Changes to 2010 UAM References:

Revisions to the 2010 Design Standards:

DESIGN STANDARDS MODIFICATIONS

From Year 2010 - Effective Date 7/1/1010 to Year 2013 - Effective Date 1/1/2013

Std Index 635

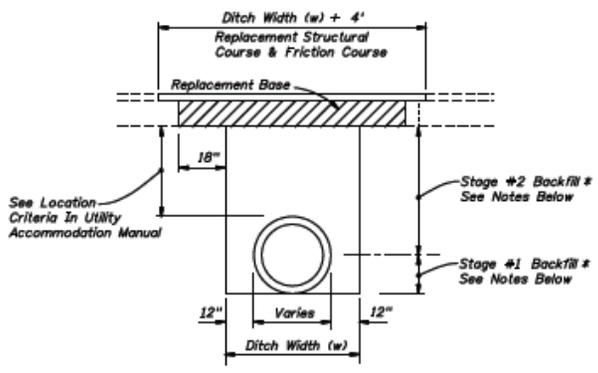
Added Buffer Space Table and note.

Index No. 635, Added Buffer Space Table and note below it “When Buffer Space cannot be attained due to geometric constraints, the greatest attainable length shall be used, but not less than 200 ft.”

MISCELLANEOUS UTILITY DETAILS

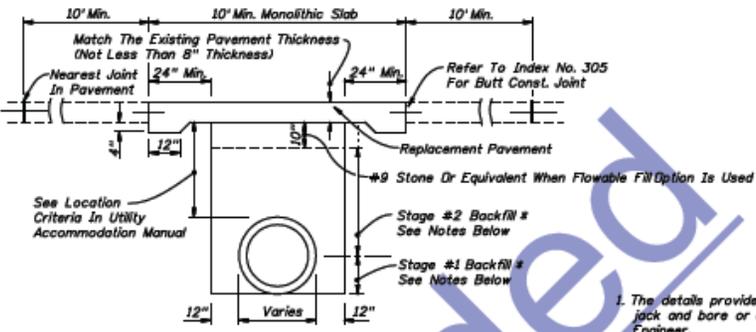
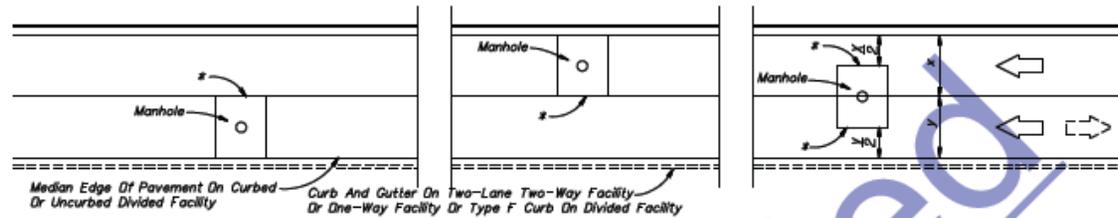
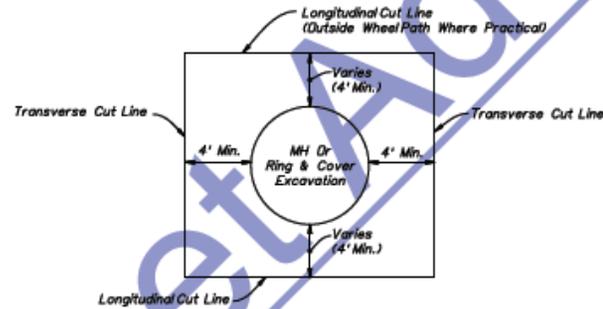
Std Index 307, Miscellaneous Utility Details

The UAM now references the entire standard rather than just conflict structures.
